To "Debby Kriegel" <dkriegel@fs.fed.us>  
cc  
bcc  
Subject Specialist Report Outline from 3-10-2008

## **Visual Technical Report**

Subject RE: Data Technology Transfer - Visual

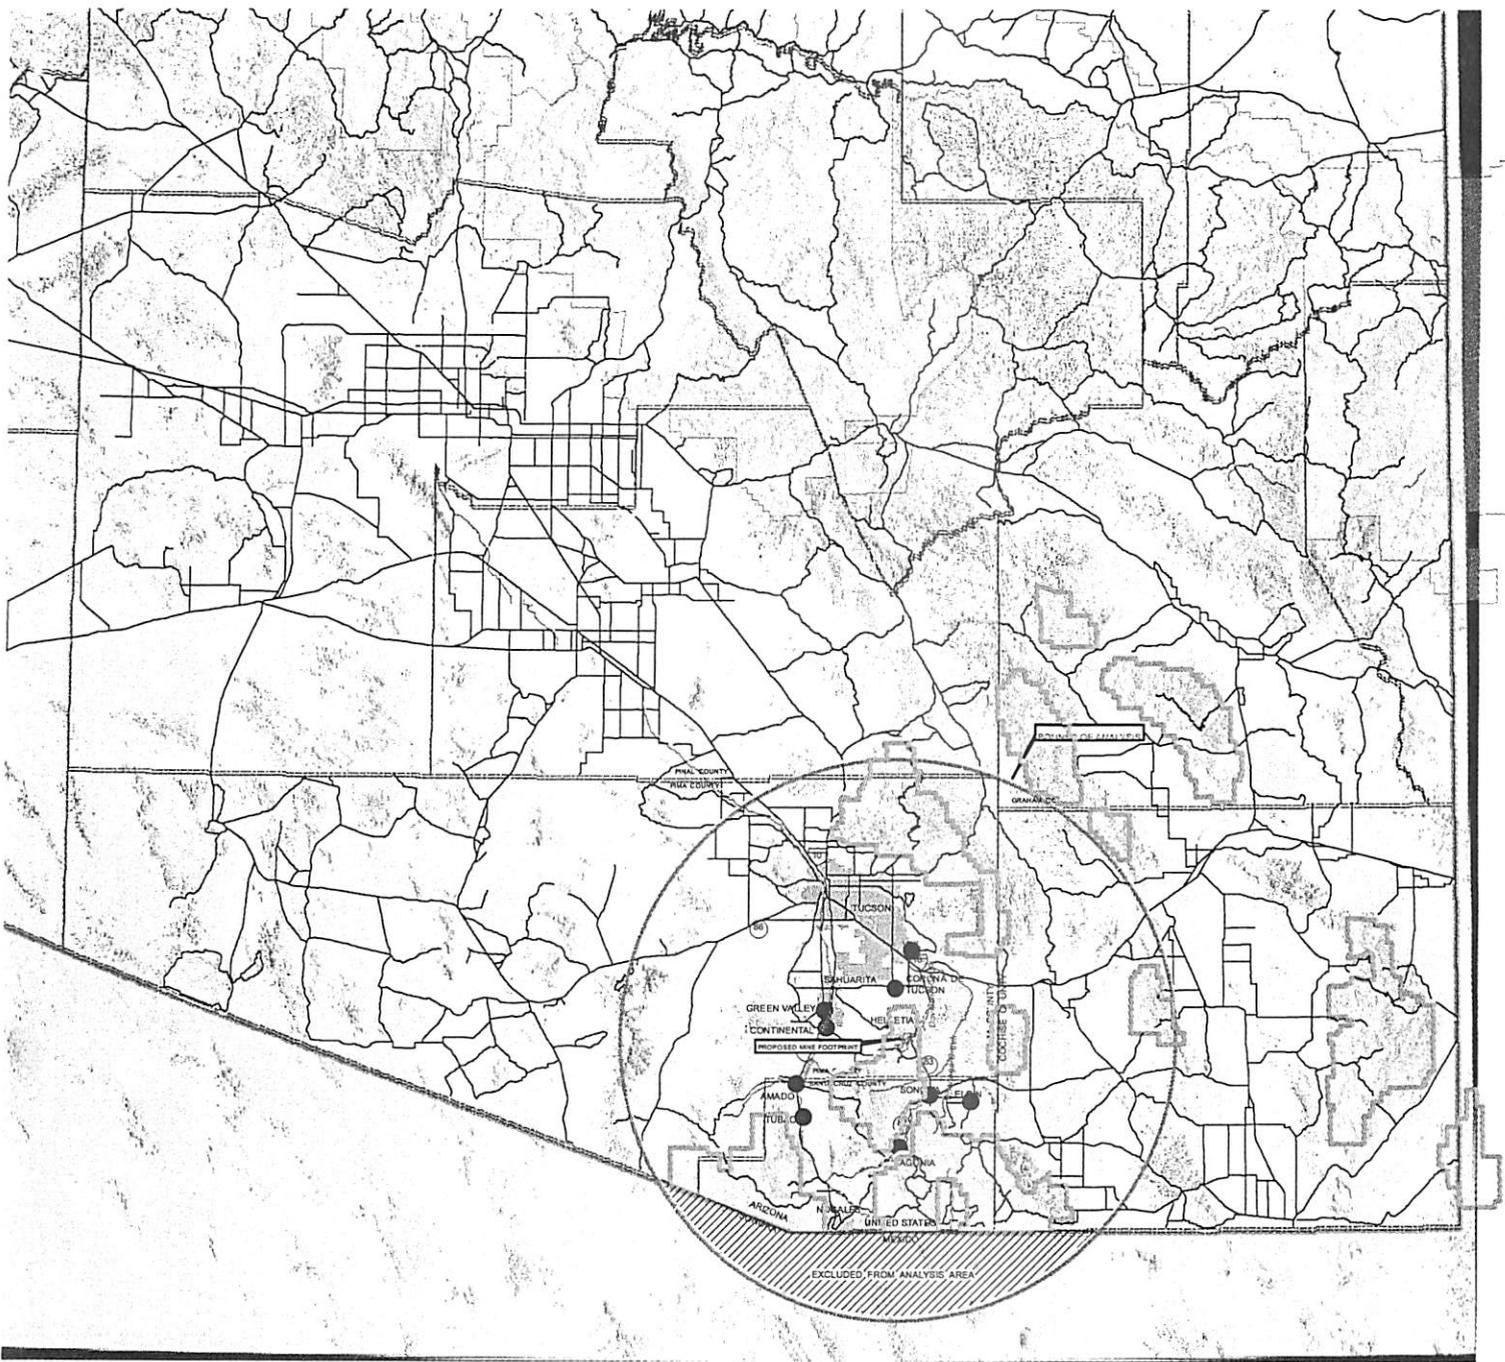
1. The temporal bounds of analysis for Land Use is intended to describe the land use planning that may impact or be impacted by the proposed project. As such, the temporal bounds of analysis include Construction, Operations, Reclamation, and Post-Closure.

2. Geographic- The potential impacts to Land Use Resources include the project area and surrounding lands as they are managed for land use, and are defined as (1) the project site (project boundary), (2) Nogales Forest Unit, (3) Coronado National Forest, and (4) southern Santa Cruz and northern Pima Counties.

***If "northern Santa Cruz" and "southern Pima" is hard to define (perhaps cut them in half), then we could use the whole counties. Either way.***
